Response to Submissions

Student Accommodation

13-23 Gibbons Street, Redfern

SSD 9194

Figure 4: Comparison between massing of the complying scheme (left) and proposed scheme (right)
(source AJ+C Architects)

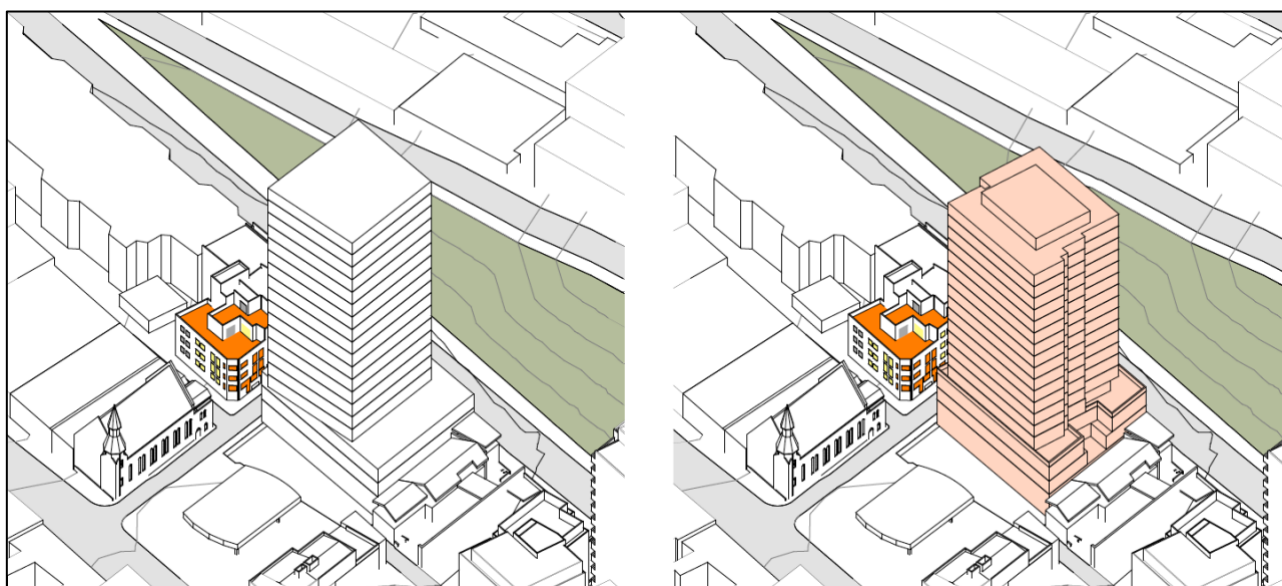
As recommended by the Department, additional analysis has been carried out, to compare the impacts of the proposed built form, with a 'compliant' built form, that is with a building form that would comply with the height, FSR, and expected setbacks under State Environmental Planning Policy (State Significant Precincts) 2005 (the SSP SEPP) and Redfern Centre Urban Design Guidelines.

A comparison between the proposed scheme and a 'complying' scheme can be seen in **Figure 4**.

Figure 6: Extract from proposed revised Tower Floor Plan showing setbacks
(source AJ+C Architects)

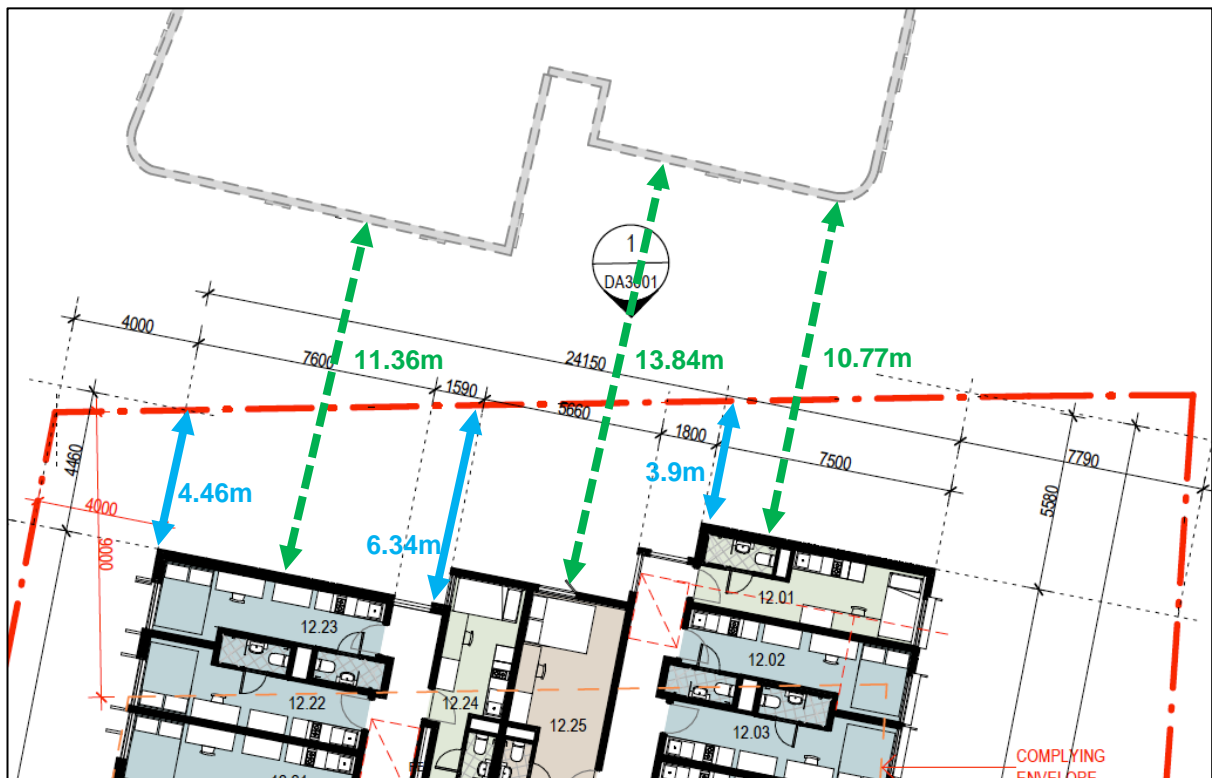
- (c) *The proposed northern tower setback does not provide sufficient building separation to 11 Gibbons Street. Further consideration shall be given to providing a greater northern tower setback to improve the visual relationship and building separation between the development and 11 Gibbons Street.*

As described in **Section 2**, improvements have been made to the setbacks of the tower on all elevations, resulting in a more slender appearance to the tower as viewed from all directions. Specific improvements to the northern tower setbacks and separation with 11 Gibbons Street are shown in **Figures 5 and 6**.

Figure 10: Early Morning Winter Sun View Diagrams showing impact of proposal (coloured orange) and impact of compliant scheme (orange dash) on Gibbons Street Reserve
(source AJ+C Architects)

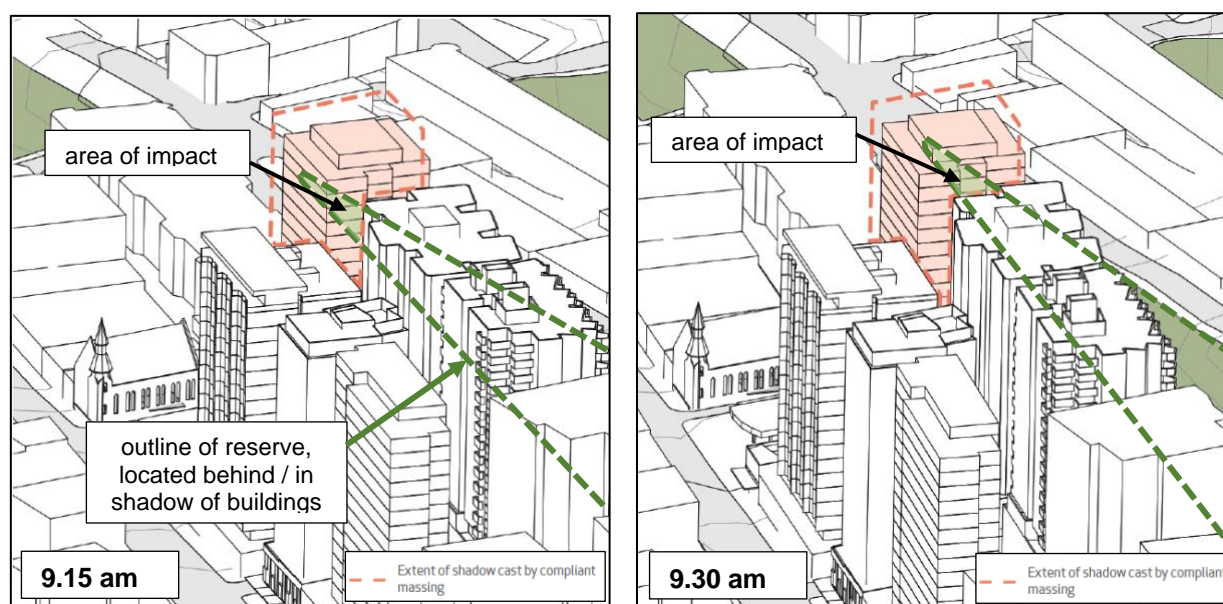
- (a) *Provide hourly shadow diagrams to demonstrate a comparison between the overshadowing from the existing development, a development compliant with the required height and setbacks and the proposed development.*
- (b) *The overshadowing impact of the proposed development must be quantified. This is to demonstrate and justify the amount of overshadowing from the proposed development in comparison to a development compliant with the required height and setbacks. Specifically, further information and justification is required for the following sites*
 - *Gibbons Street Reserve*
 - *St Luke's Presbyterian Church*
 - *1 Margaret Street (each unit)*
 - *National Centre of Indigenous Excellence playing field, 160-202 George Street*

Gibbons Street Reserve is only materially affected by shadowing in the early mornings at midwinter. Following development, about half of the reserve will be in sunlight after 9.40am, and after 10.00am the reserve will generally be free from shadows and enjoy very good levels of solar access throughout the day. The shadow and sun view diagrams demonstrate that once the shadows of adjacent approved buildings are taken into account, the shadow impacts of the proposed building on the reserve are negligible, given the proposed building sits largely within the shadows of the surrounding approved buildings (**Figure 10**). Further, the proposal would result in no greater impact to the reserve than a compliant scheme. Calculations demonstrate that 80% of the reserve will retain 7 or more hours of solar access through the day.

Figure 14: View lines at Ground Floor level
(source: AJ+C Architects)

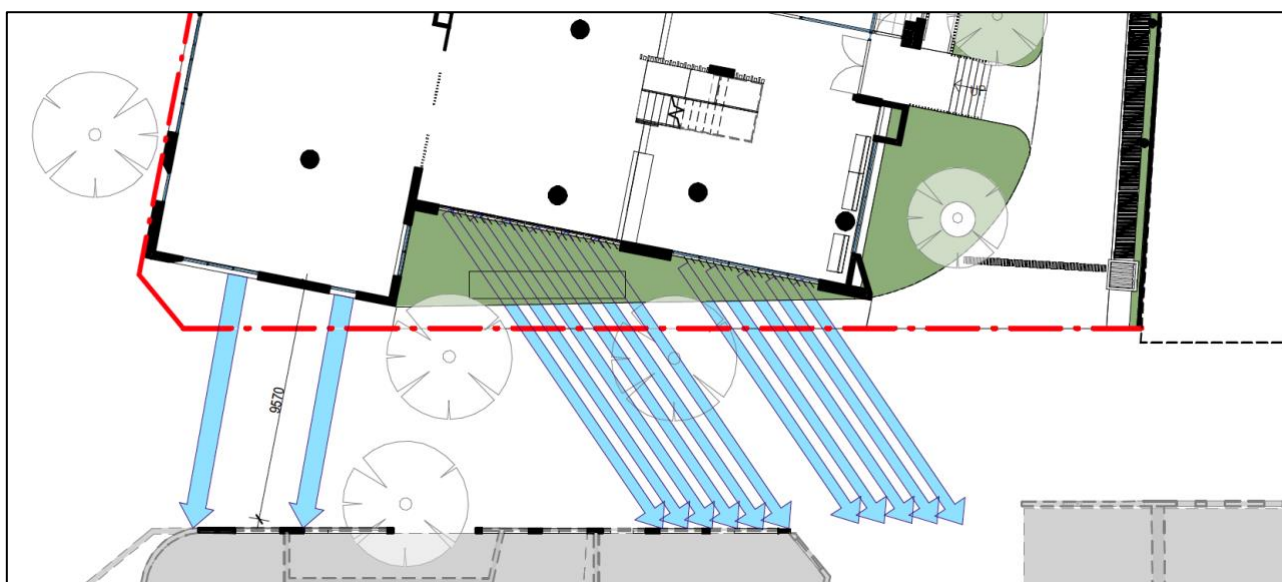
A visual impact assessment, including consideration of visual privacy impacts has been included in the Supplementary Design Response at **Appendix D**. A detailed consideration of how privacy has been addressed on the elevations facing 1 Margaret Street and 11 Gibbons Street is set out below.

The proposed podium provides greater setbacks than expected under the SSP SEPP and the UDPRC and therefore is likely to result in a better outcome for visual privacy than a development built strictly in accordance with the controls. The increased setbacks as compared to the controls allow for planting of two street trees (Watergums to a mature height of 7 metres) as well as setback plantings including a native frangipani which will assist with softening direct view lines between the sites.

Vertical screens are proposed for the ground floor common room windows and south facing bedrooms at Levels 2 and 3 to redirect view lines, and maintaining views of the street, but reducing direct overlooking between the two sites (**Figures 14** and **15**). Obscure glazing is also proposed for corridor and secondary windows at Levels 2 and 3.

Figure 20: Existing (left) and Proposed (right) setbacks from Church building
(source: AJ+C Architects)

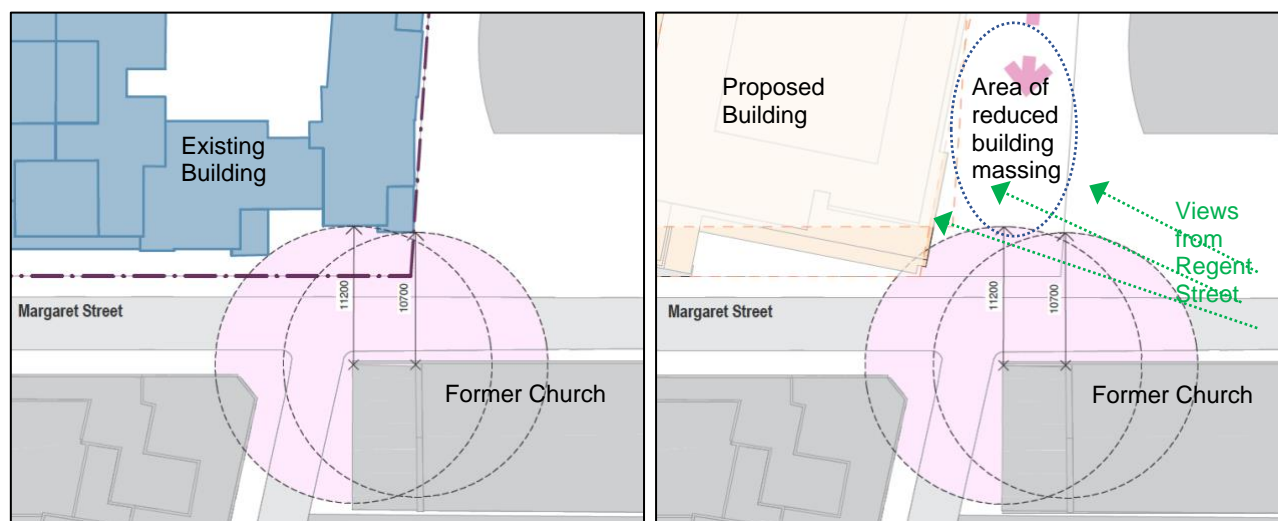
- (a) *The proposed development should provide greater setbacks to Margaret Street to maintain sufficient separation to St Luke's Presbyterian Church. Any encroachment is to be justified within the context of heritage impact.*
- (b) *A photomontage is required from view Plate 17 to demonstrate the view westward along Margaret Street.*
- (c) *The arched 'feature window' proposed on the south east-facing elevation is likely to detract from St Luke's Presbyterian Church and should be reviewed.*

The RTS has also revised the design of the building so that both the podium and the tower will be setback further from the former church than the original proposal.

Overall, the amended proposed setbacks represent a significant improvement from the planning controls which apply to the site and which do not seek a setback from the former church, but rather, envisage a podium built to the eastern and southern boundaries, which would result in a setback of 7 metres from the church.

Further, the proposed building arrangement results in an improved area of visual curtilage for the church as compared to the existing development on the site. The existing building on the site has a setback of 10.7 metres from the church at its closest point. The proposed podium would also have a setback of about 10.7 metres, but increases the visual curtilage of the church, particularly as viewed from the front of the church on Regent Street, due to the reduction in building massing in the area proposed for the through site link. That is, as viewed from Regent Street the proposed building would be further away, and therefore more in the background of views of the church as compared to the existing building (refer to **Figures 20 to 22**).
